From: Battaglia, Frank
Sent: Tuesday, October 23, 2018 6:11 PM
To: 'Rick Kowalski'; Tisa, Kimberly; jeff.crawford@dem.ri.gov
Cc: Joseph F Guarnaccia; Stephen Graham; Aaron Ting; Wainberg, Daniel; Battaglia, Frank
Subject: RE: Cranston - TP-5 Area Excavation Progress - APPROVAL to backfill
Attachments: View of Site from RR Bridge.docx; TP-5 Area Excavation Photo 10-10-18 (003).docx; TP-5 Excavation Cross-Section 10-15-18.pdf; TP-5 Excavation_Post Excavation Sample Locations_10-17-2018.pdf

BASF Cranston

BASF Cranston
TP-5 Area Excavation along the River
October 10, 2018

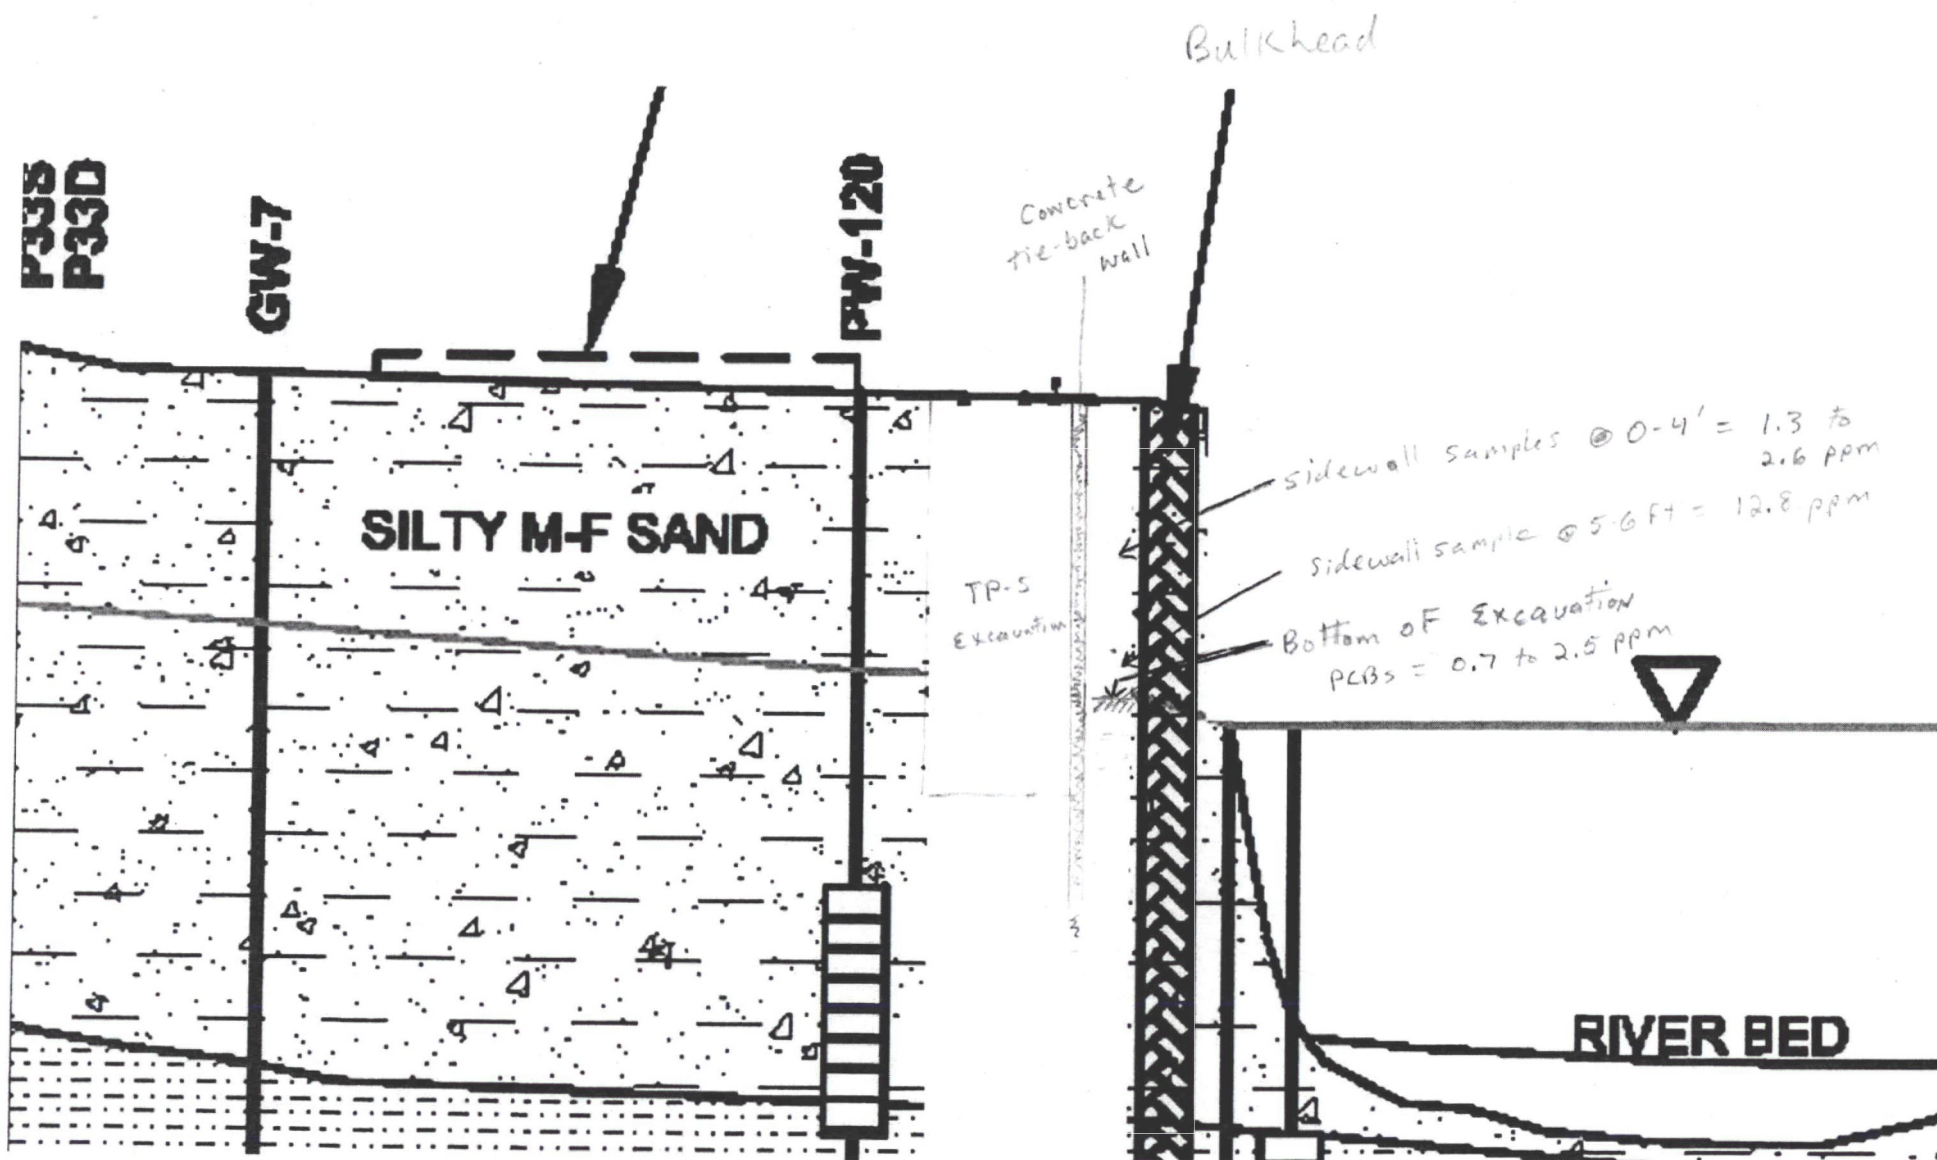
We have encountered an area along the river in the floodway (one edge of the TP-5 area excavation) where we have encountered a concrete wall that appears to be a tie-back for the cofferdam wall along the river. Attached is a photo of the excavation which shows this structure. Note that the fence along the river is to the left in this photo.

It does not appear to be possible to excavate further (deeper than the existing 6 ft or wider than the existing sidewall) without risking damage to this structure and/or the cofferdam. However, we have not achieved the <1 ppm goal for this area. The locations of these samples are shown on plan view and in a cross-section on the attached figures. Therefore, BASF is requesting your approval to leave these remaining soils in place. The existing data for this area is as follows:

B-797 @ 6 ft = 1.5 ppm
B-807 @ 6 ft = 2.5 ppm
B-813 @ 6 ft = 1.3 ppm
B-801 @ 6 ft = 0.7 ppm

SW-569 @ 5-6 ft = 12.8 ppm
SW-570 @ 0-4 ft = 1.3 ppm
SW-574 @ 0-4 ft = 2.6 ppm

The results for the other sidewall samples along this sidewall (SW-571, 572, 573, 574 and 568) were all <1 ppm. Please note that the water table is at a depth of approximately 3.5 ft below grade in this area.

Rick, I spoke with Chuck Horbert in the RIDEM Wetlands program, Kim Tisa and Jeff Crawford and we are all in agreement that the concrete structure, as shown in the attached photos, that you encountered along the river bank that is impeding the removal of some PCB contaminated soil at the 6 foot depth is part of the sheet pile retaining wall for the river bank and it should not be disturbed or damaged. Since this work is being conducted under a PCB Risk-Based Disposal Approval (PCB Approval) and the concentration of PCBs remaining in that area, as listed at the bottom of this e-mail string, is less than 13ppm, there should be no additional risk to human health or the environment by leaving the remaining soils in place and backfilling with clean soil and, therefore, you can begin backfilling the area. EPA will need to modify the PCB Approval to account for this slightly higher concentration of PCBs to remain at depth at this location and we will get back to you if we need any more information. In addition, the ELUR should clearly identify the area and depth where concentrations of PCBs will exceed the 1ppm target and the closure report should include photo documentation, detailed figures and lab analytical results. Please contact me or Kim Tisa if you have any questions.

Rick, if the concrete wall is restraining the sheet pile wall which holds the river bank in place, then we do not want to remove it since it is a critical support structure for the river bank. Any idea if that is the case?

View of Site from RR Bridge, looking northwest

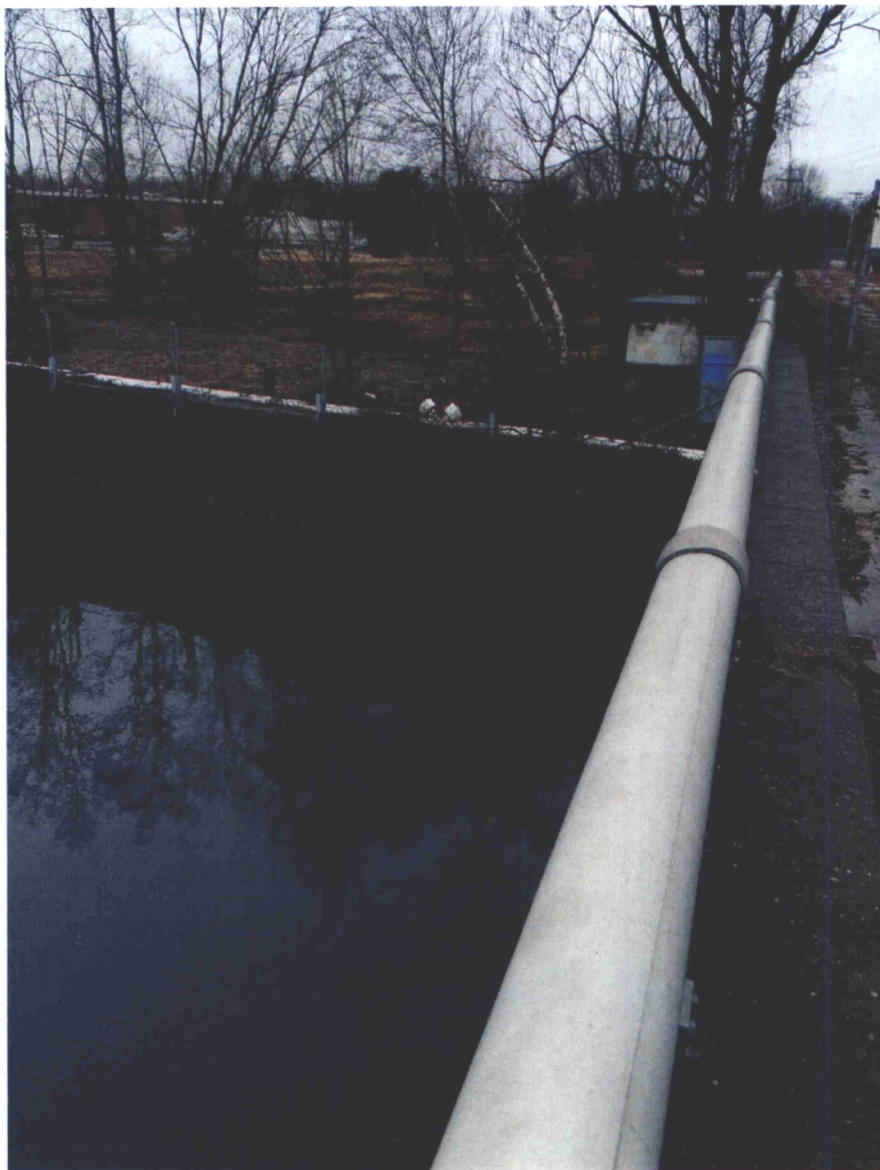
Ok, thanks. Please note that maybe "cofferdam" is the wrong terminology for the sheet pile wall along the edge of the river that is definitely still in place from the bridge, up the river almost all the way to the Safety Kleen property. See attached photo which shows the sheet pile wall as seen from the bridge. Thanks,
